GTR-EVS TF6 State-of-Charge

Position of OICA to the Proposal for Adjustment of State of Charge provided by NHTSA, Oct 10th 2015:

Figure 1: Voltage (V) vs State of Charge (%) for Various Lithium Ion Battery Cathode/Anode Couples (Source: Ford Motor Company, published at 2015 Battery Symposium Japan 56, Nagoya, JP, November 11, 2015)

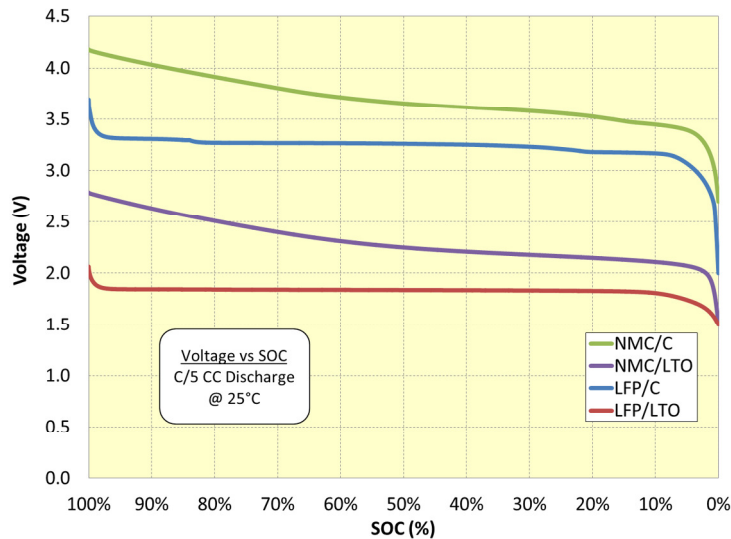
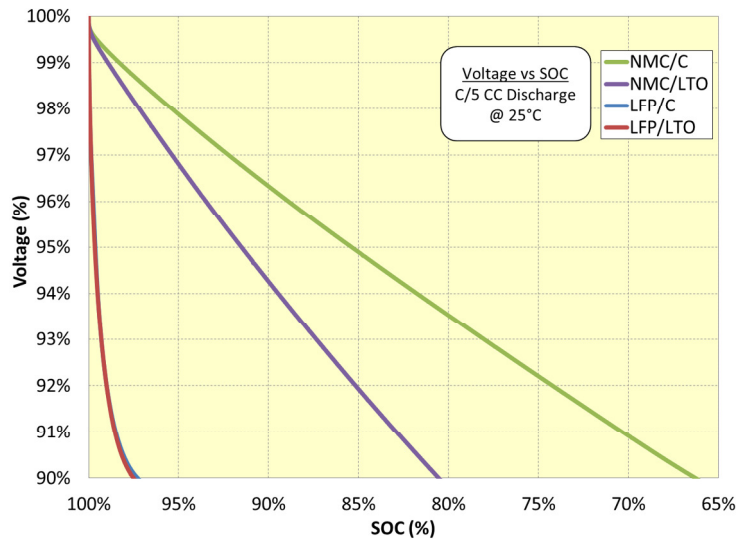
It is further important to keep the relative complexity of assessing the actual SOC – in contrast to the OCV – in mind. Depending on the cell chemistry used there can be very minor influence of SOC on

OCV (see figures 1 and 2), at least within the nominally used SOC ranges (e.g. between 20% and 80% of physical cell capacity range), while there may be influence of the saturation time and the speed of charging, but also of the charging temperature. These factors may prevent using OCV as suitable indicator for absolute SOC levels. When in practical levels OCV is monitored the purpose is to check relative changes from a known SOC level. Ideally then an OCV-check will show minimal ΔV , indicating SOC is preserved.

Figure 3: Peak Heat Rate (W) vs. Depth of Discharge (%) (Source: Sandia National Lab, Published at 2015 US DOE Annual Merit Review, #ES203)

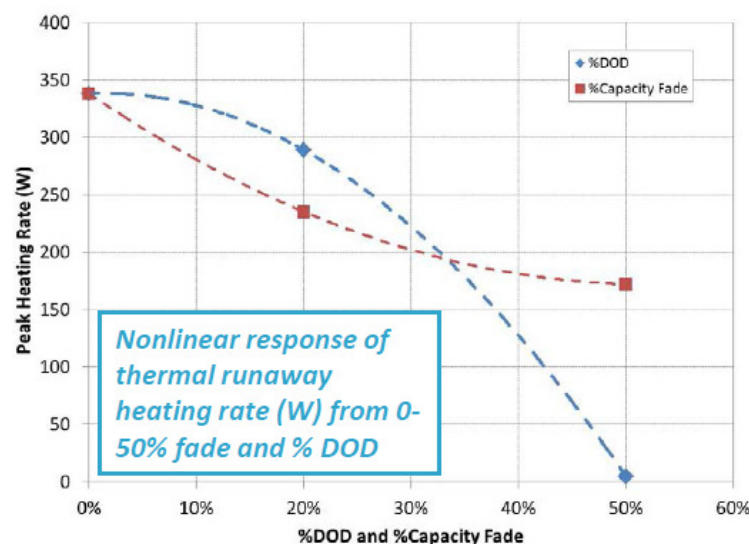
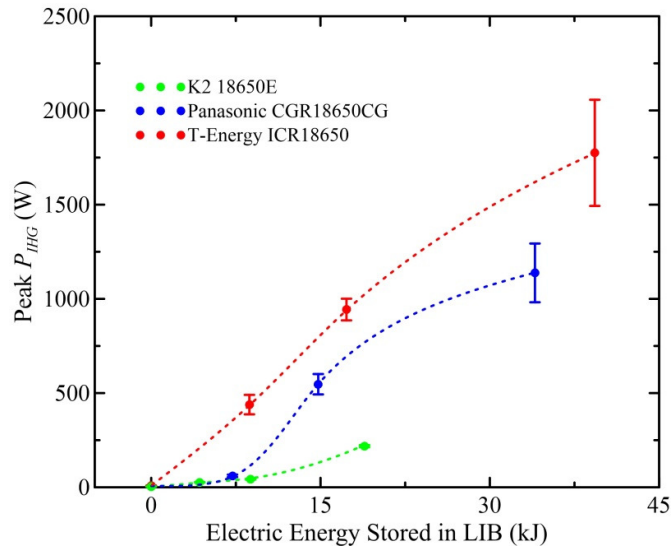
In NHTSA's justification, an exponential behavior of lithium ion battery thermal peak power is cited as the motivation for the SOC set point of 95%. Peak power is one of only several factors that can be used to describe a thermal event, along with duration, average power, energy, etc. Notwithstanding the many ways to characterize the thermal intensity of a thermal event, several other published tests of lithium ion batteries have shown a linear relationship between peak power and SOC, not exponential as NHTSA has shown (see Figure 3 and Figure 4).
